Canada Parks Agency
REHABILITATION LACHINE CANAL WALLS
CROWNING WALL REPAIRS AND REPLACEMENT
(SECTORS 5.2; 6 & E – BASIN N°3)
Project N° CLAC-1455-06
Addendum n° 01

MODIFICATIONS ON PLANS AND SPECIFICATIONS

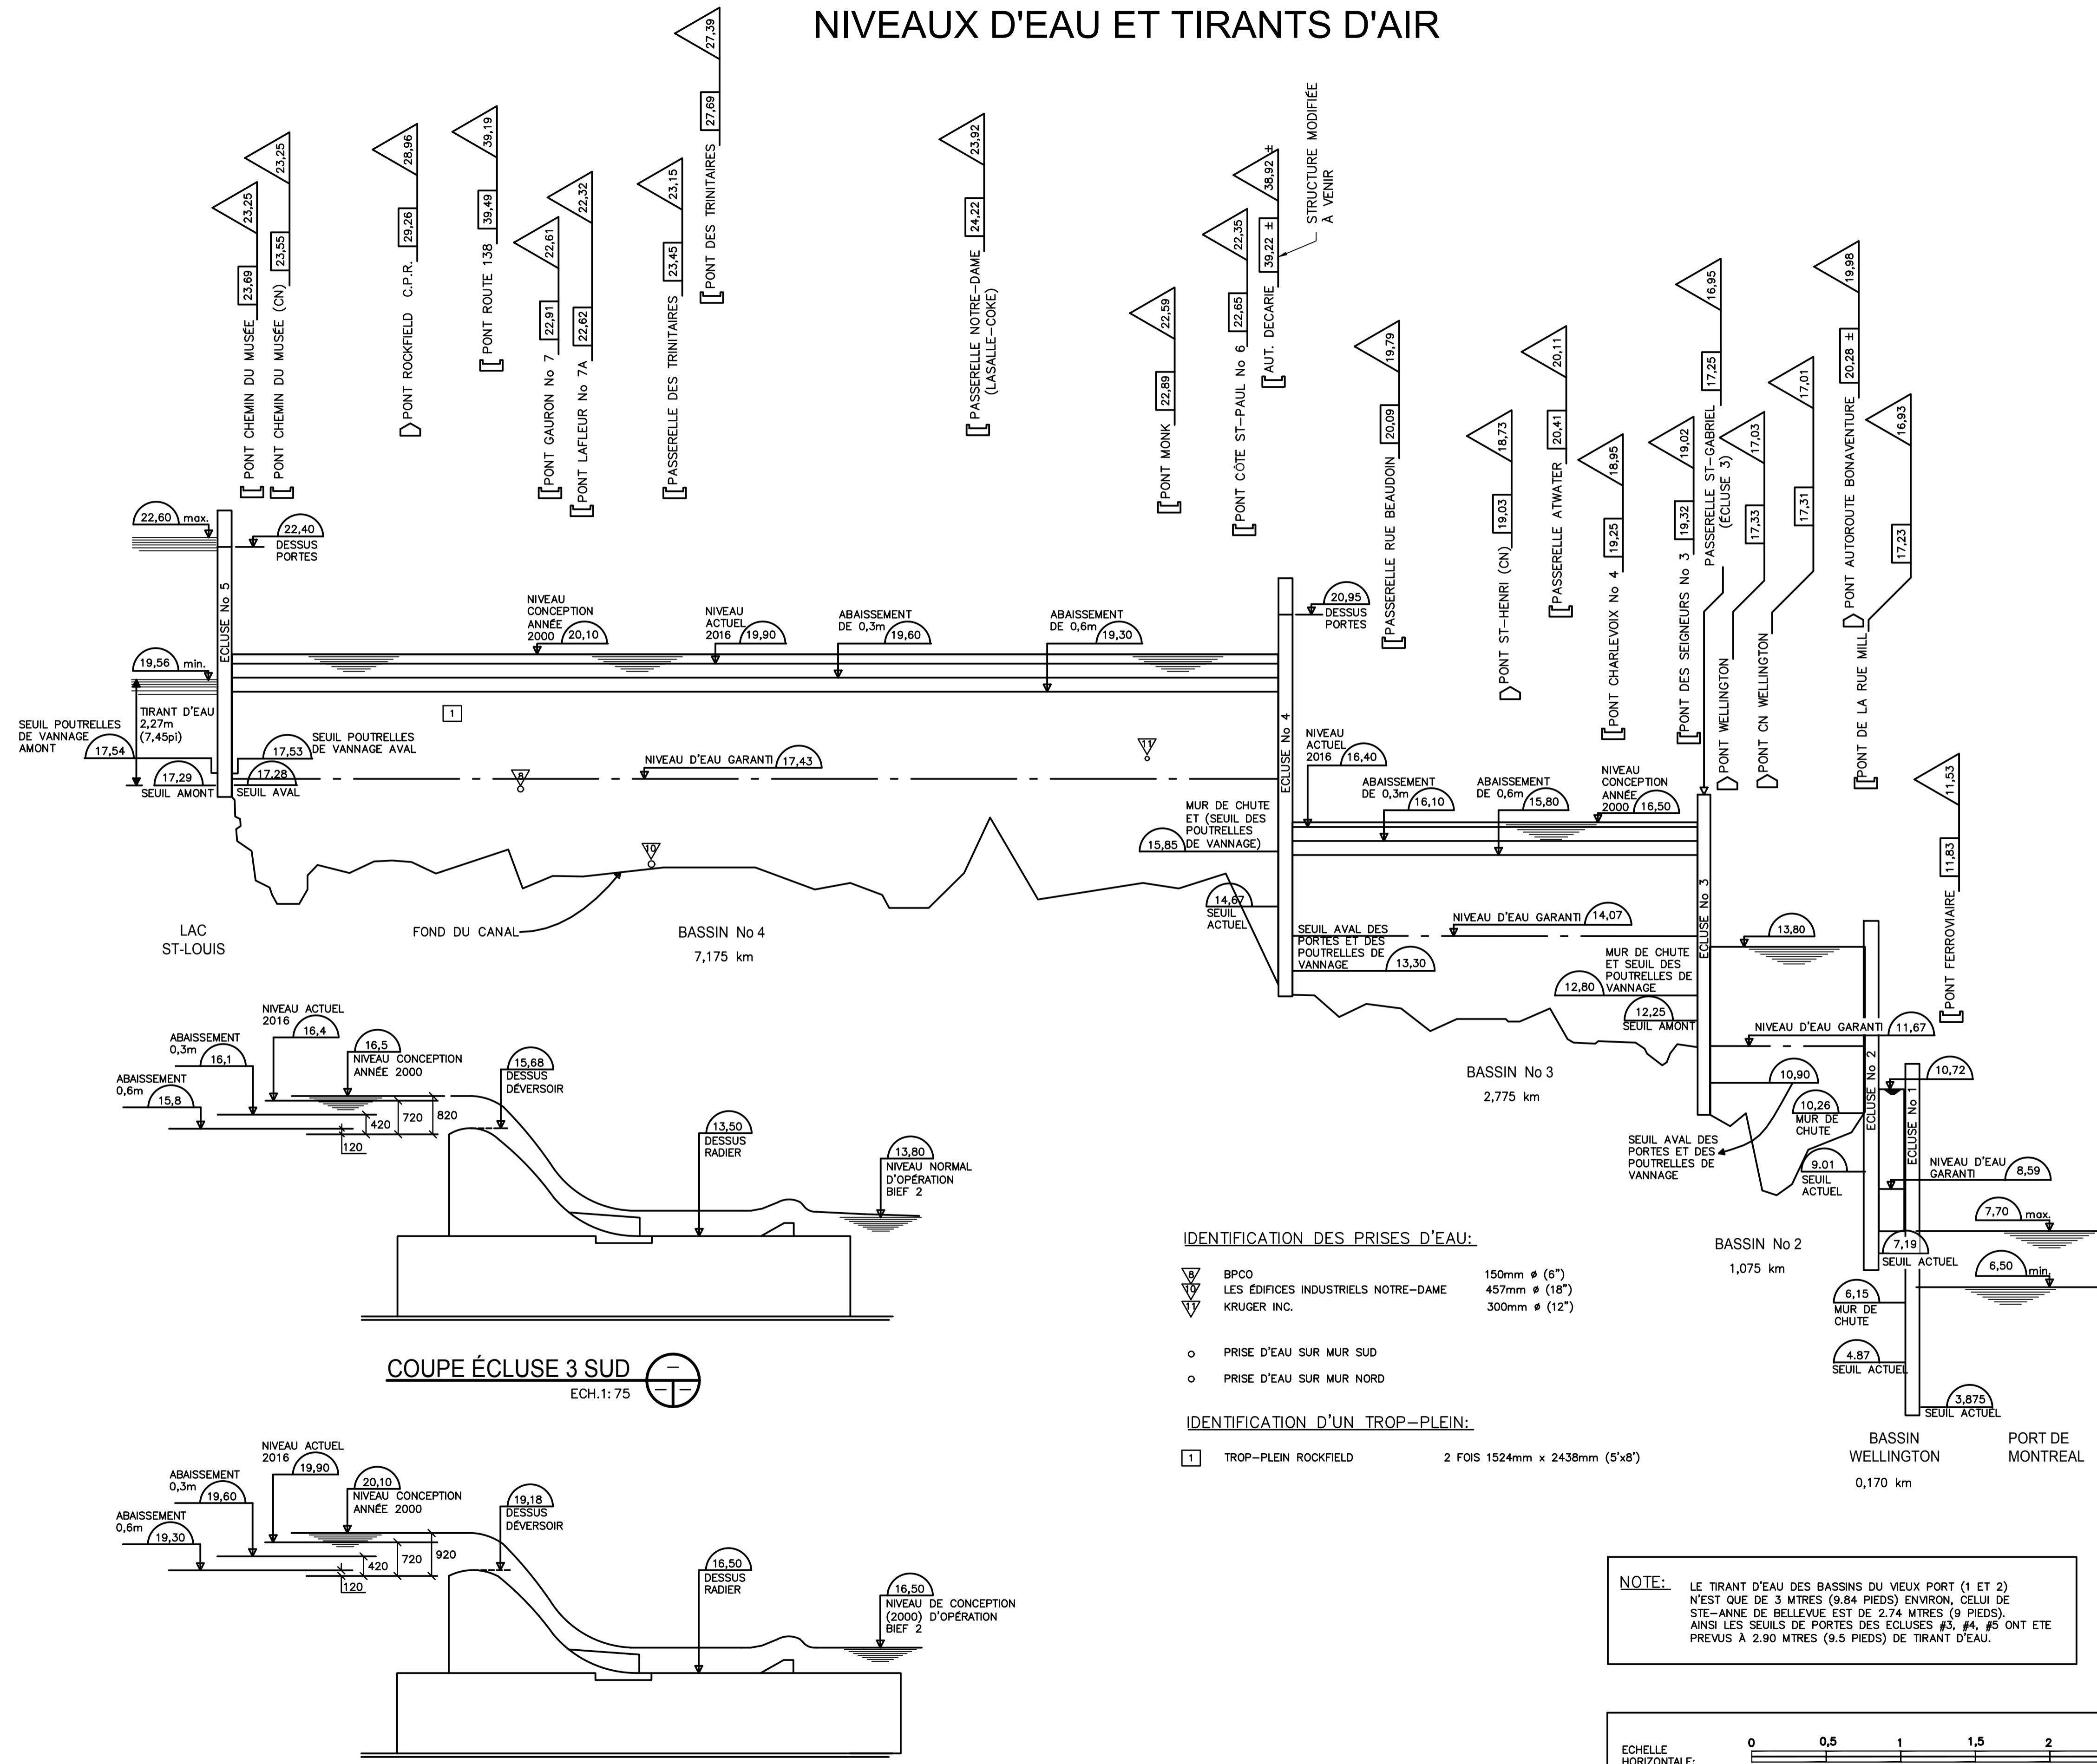
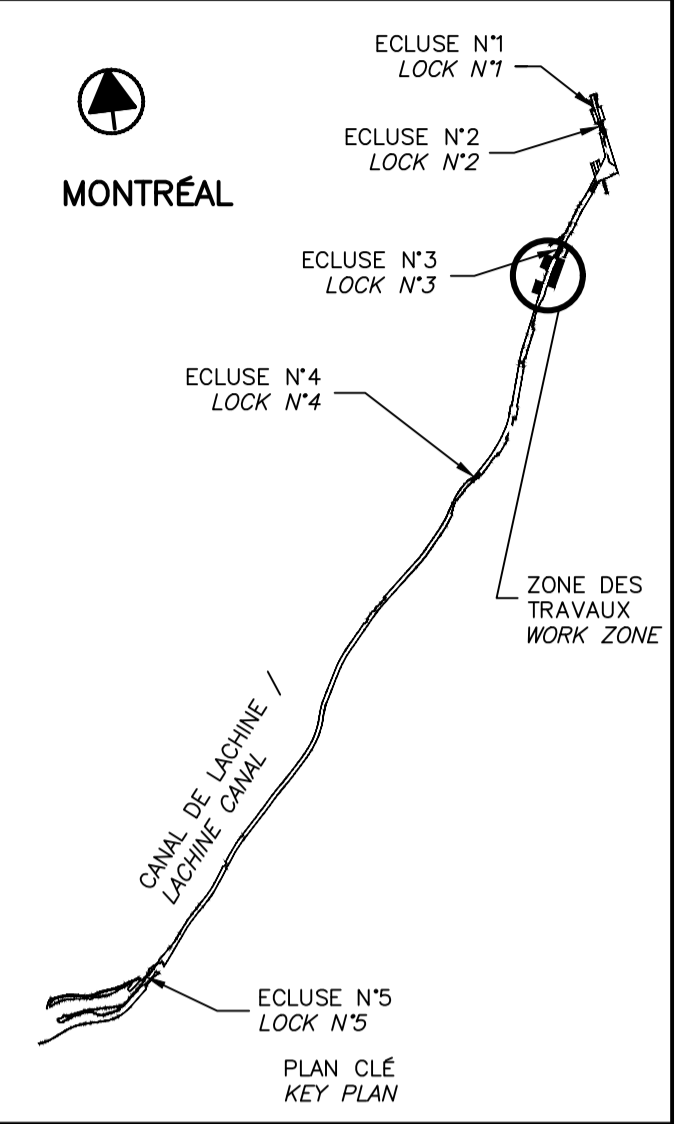
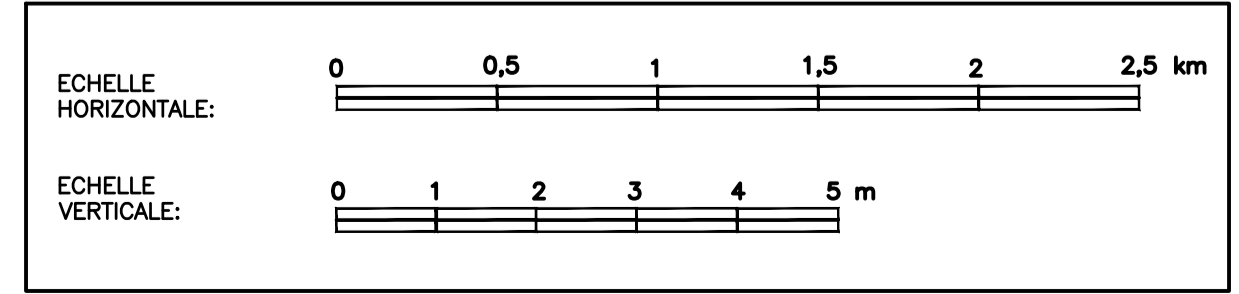
- Sheet 25 Addition of additional information to illustrate water level and vertical clearances.
- Sheets 26 à 28 Addition of 3D survey of various sectors. See plans in annex of this addenda
